June 5, 2002

**Subject: Meade Street Operable Unit, Subunits 1 and 2A  
U.S. Army Corps of Engineers File Number 26417S**

## II. Proposed Modifications to the Project

FIRST PHASE OF  
 EXCAVATION ACTIVITIES  
 (August 1 -September 1, 2002)

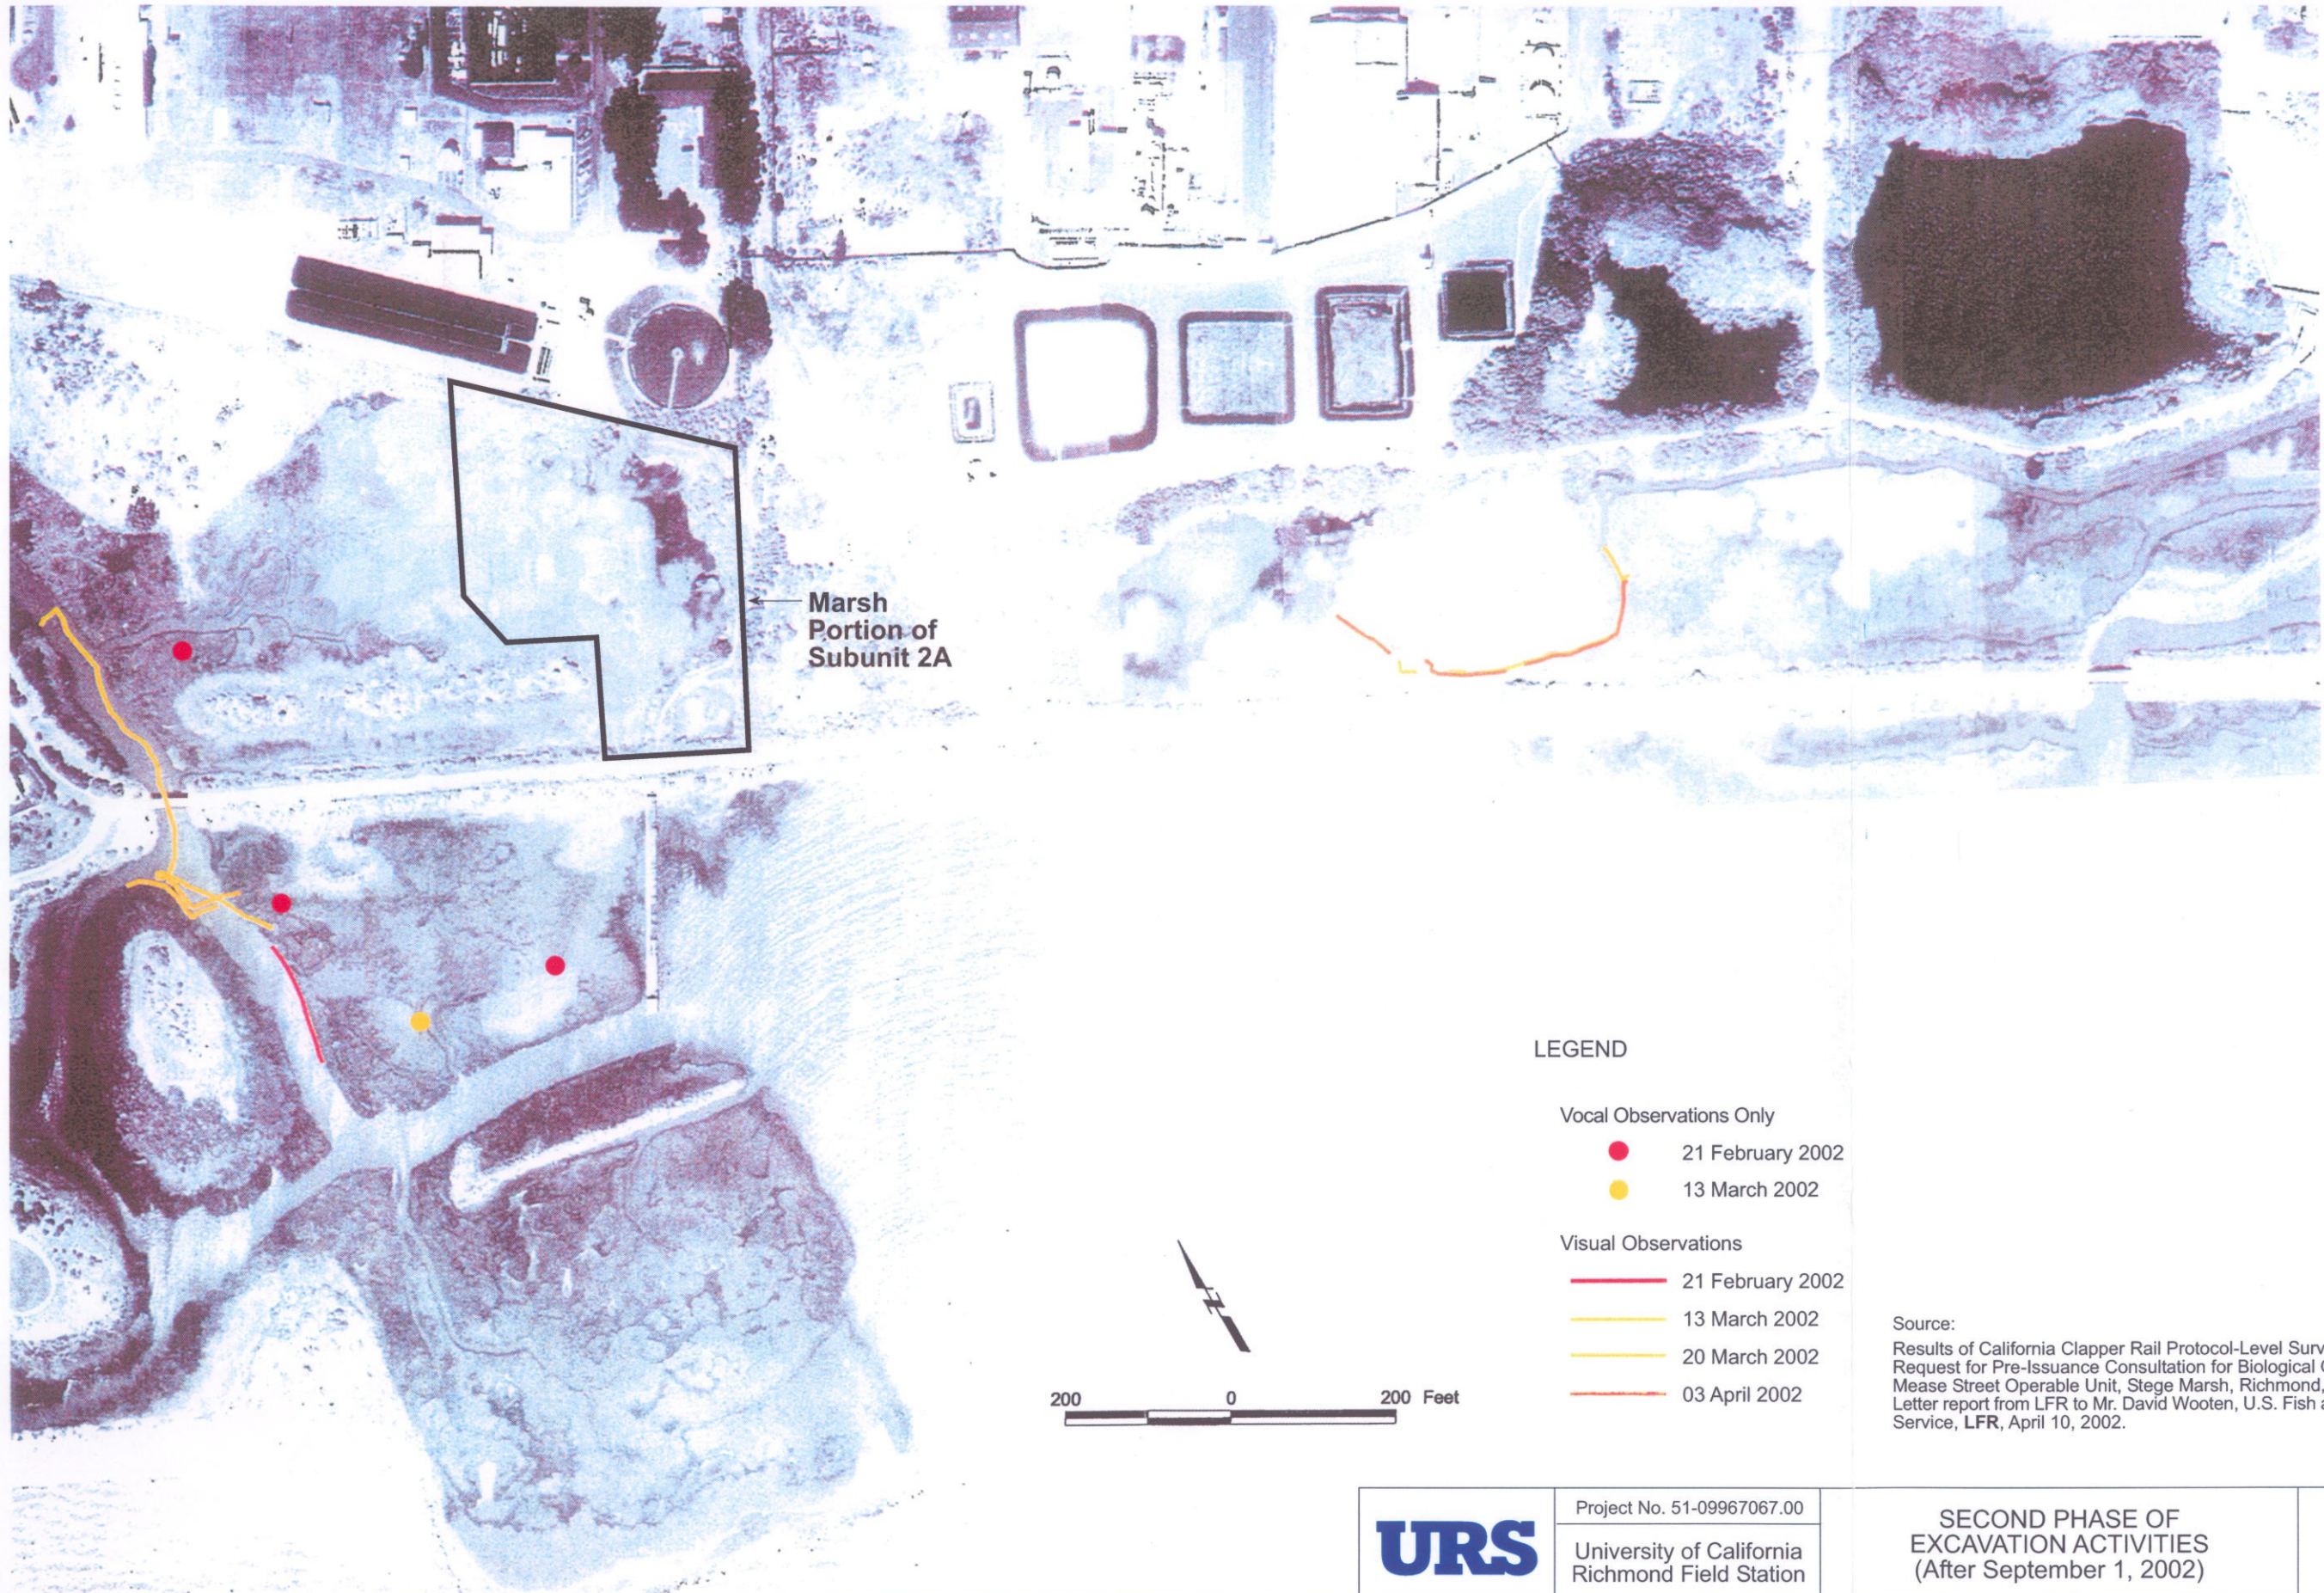
- Work will only be conducted in the upland portion of Subunit 2A and the western portion of the upland landfill in Subunit 1 during the end of the breeding season after August 1, 2002;
